City of Parramatta	
File No:	DA/14/2023

SECTION 4.15 ASSESSMENT REPORT
Environmental Planning & Assessment Act 1979

DA No:	DA/14/2023
Subject Property:	Lots 7 & 8 in DP 219954 & Lots 1 & 2 in DP 869976, 7-7B St Andrews Street & 79-79A Kissing Point Road, DUNDAS
Proposal:	Demolition, tree removal, site consolidation and construction of two part 5 and part 6 storey residential flat buildings with 3 levels of basement carparking. The application is Nominated Integrated development pursuant to the Water Management Act 2000.
Date of receipt:	13/01/2023
Applicant:	HVH Investment Pty Ltd
Owner:	HVH Investment Pty Ltd
Property owned by a Council employee or Councillor:	The site is not known to be owned by a Council employee or Councillor
Political donations/gifts disclosed:	None disclosed on the application form
Submissions received:	6 submissions received within the notification period
Recommendation:	Refusal
Assessment Officer:	Denise Fernandez

Figure 3: Elevation from St Andrews Street. Source: Texco Design

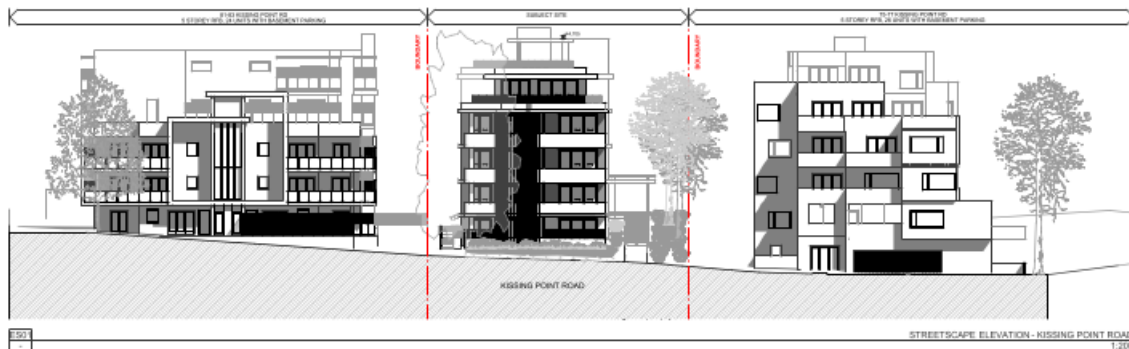
The issues with the proposal arise from the design of the development, primarily that the building that presents to the St Andrews Street frontage is designed with an excessive floor plate width and with the breach in height results in a bulky built form, particularly when viewed from the street.

Comment: The subject site is the last parcel to be developed along Kissing Point Road and on St Andrews Street as a high-density residential development. With respect to scale, the bulk of the building (particularly when viewed from the St Andrews Street frontage) is uncharacteristic of the locality. The variation to the height along with the excessive floor plate width of the development on St Andrews Street dominates the streetscape.

Figure 3: Proposed Height breach outlined in red. Source: Texco Design.

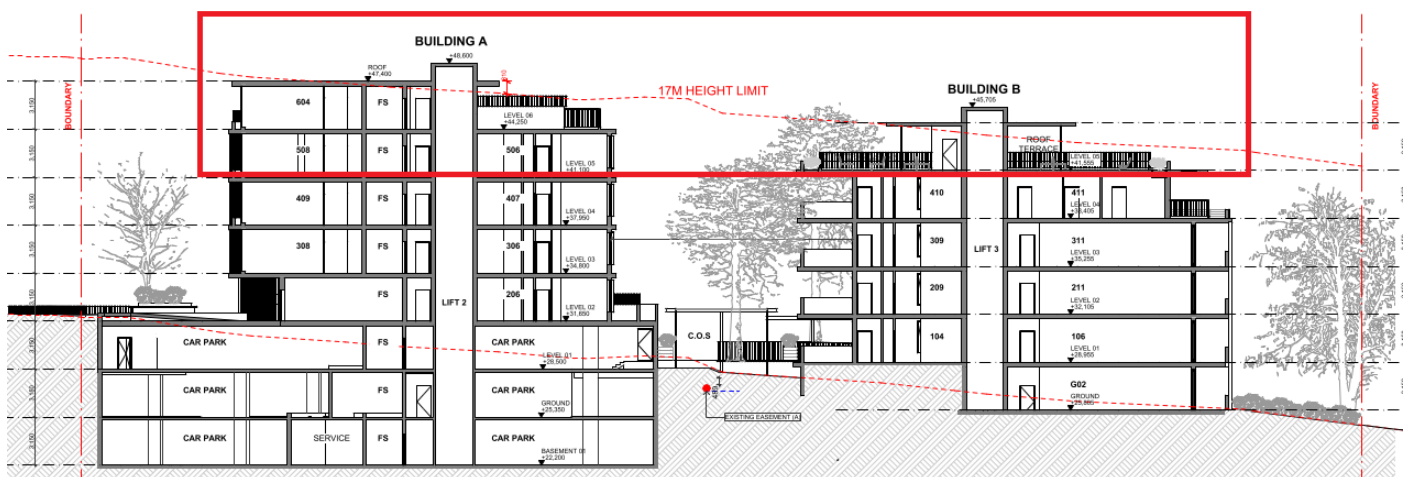
Comment: As shown in **Figure 4**, the elements of the proposed building which exceed the control relate to the lift overrun and the roof of the rooftop terrace area. The elements that protrude beyond the height plane has not been integrated into the design of the development which currently presents as 'bulky' due to the excessive floor plate width when viewed from St Andrews Street. The overall height of the development in this instance appears to create overshadowing impacts within the development (particularly to the COS area between the buildings). Additional information has also not been submitted demonstrating the impacts of the proposal on adjoining properties.

Comment: The Applicant's assessment above has not taken into consideration the impacts of the excessive floor plate width and the lack of integration of the elements that breach the height plane to avoid a bulky development. Given this, it is not considered it has been demonstrated that there are sufficient environmental planning grounds exist to justify departing from the development standard.

Conclusion: It is considered that the elements that breach the height plane has contributed to the bulky built form of the proposal which has not been adequately addressed in the applicants written request. As such, the submitted request has not demonstrated that the variation to the height development standard within PLEP 2011 should be supported. It has therefore not achieved the objectives of the height development standard and zone and that it is not in the public interest. In reaching this conclusion, regard has been given to the relevant Judgements of the LEC.
